Burlington Development Review Board

Development Review Board

Tuesday, June 4, 2024, 5:00 PM

To: Development Review Board
From: Mary O'Neil, AICP, Principal Planner
Date: June 4, 2024
RE: ZPS-24-3; 266 / 270 Pine Street (The Soda Plant)

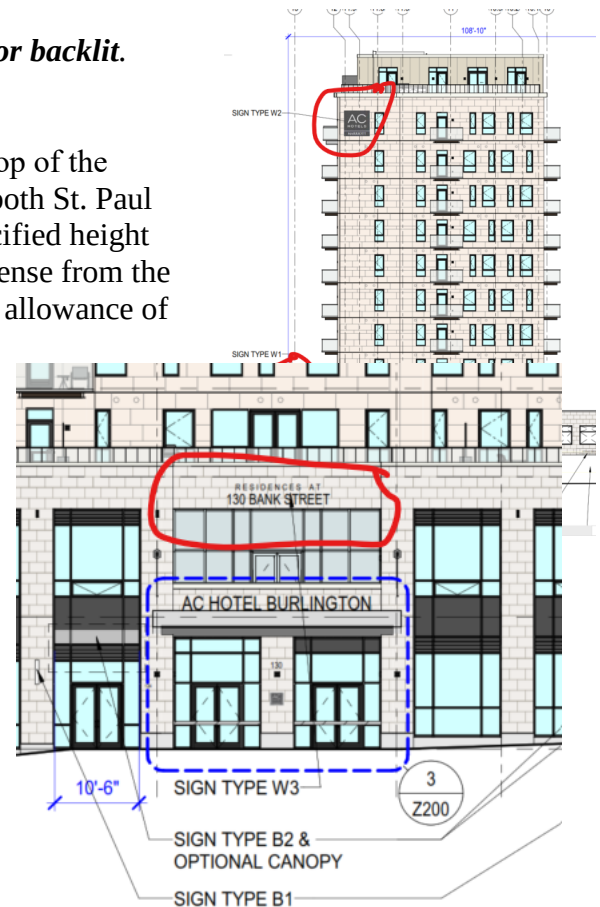
Two other wall signs are proposed: One announcing the Residences at 130 Bank, and a wall sign for the parking entrance (St. Paul St.)

The Residences sign is proposed at the floor level of the third floor, but above the hotel canopy

Flexibility in installation height is relevant here, to identify the location of the entrance as well as to allow visibility above the canopy.
